## CERTIFICATE OF APPROPRIATENESS

**Property:** 1907 Decatur, Lot 8, Block 427, Baker W R NSBB Neighborhood Subdivision. The property includes a historic 2,340 square foot, two-story single-family residence situated on a 5,000 square foot interior lot.

### **Proposal: Alteration – Porch**

**Recommendation:** Approval

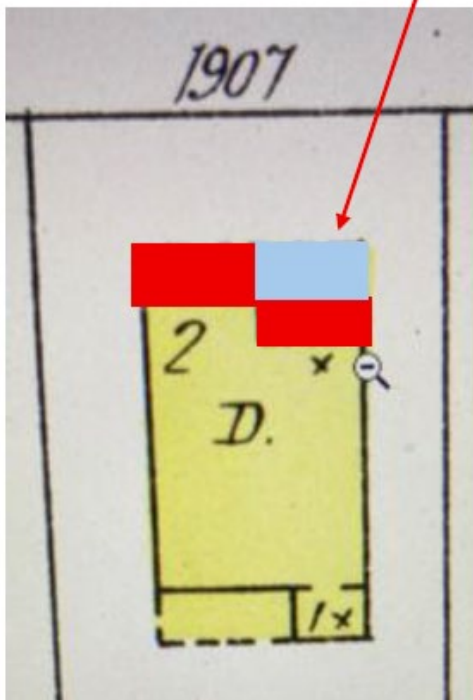
I am proposing to add a porch (blue) where part of the original 2 story porch exists. Based on the enclosures, it is not feasible to bring the house back to the original status.

NORTH (FRONT) ELEVATION

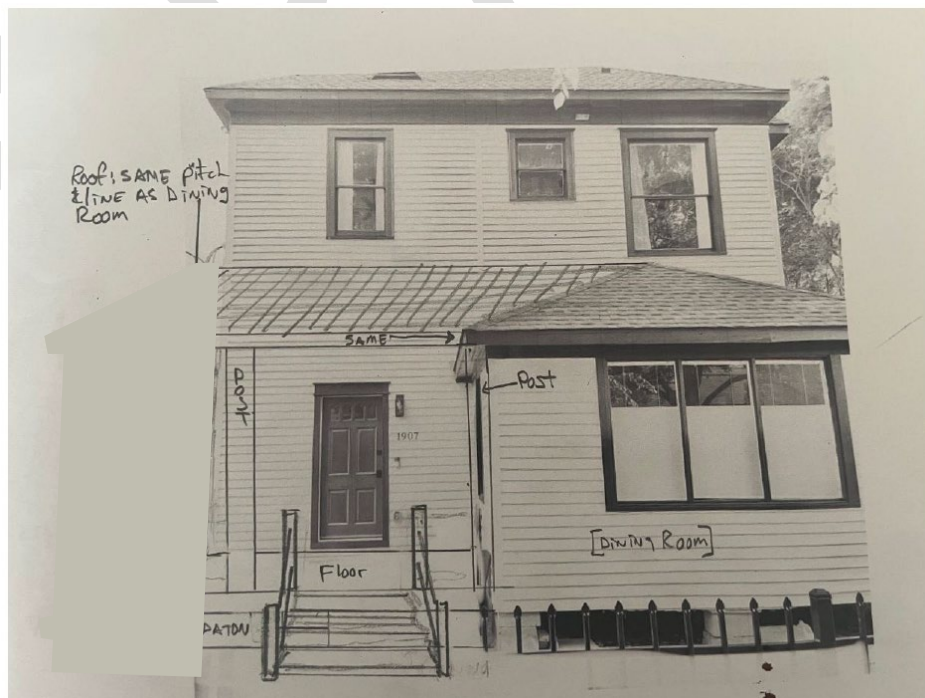
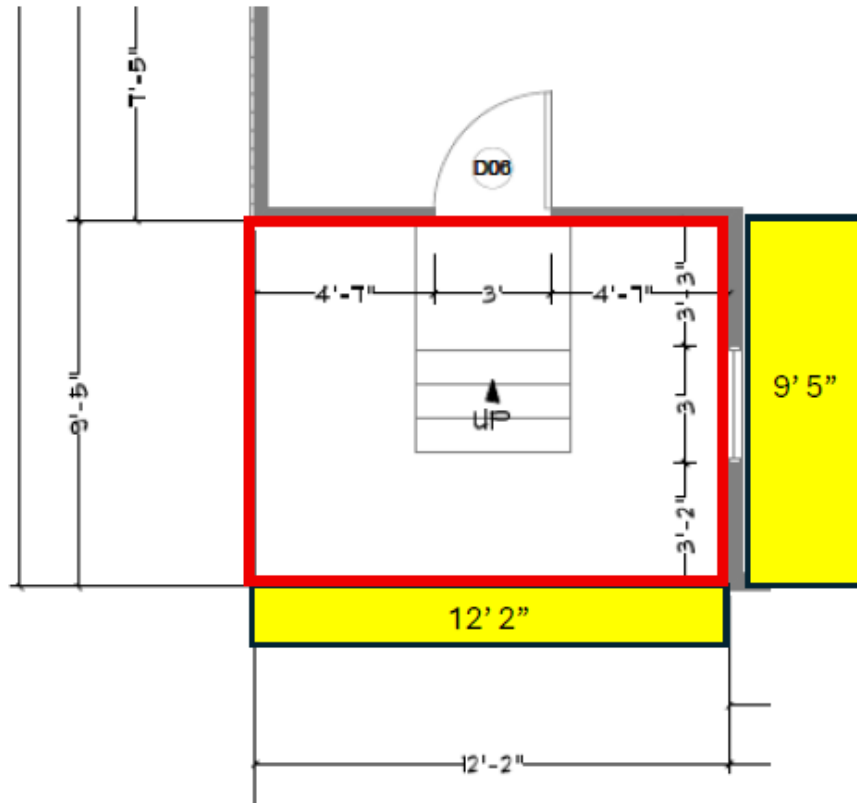
The addition of the porch, the way it will incorporate an existing roof line, the scale and materials used are all appropriate and conform to historic guidelines and to the spirit of the neighborhood and demonstrate responsible practices of renovation to a historic structure that has been substantially altered.
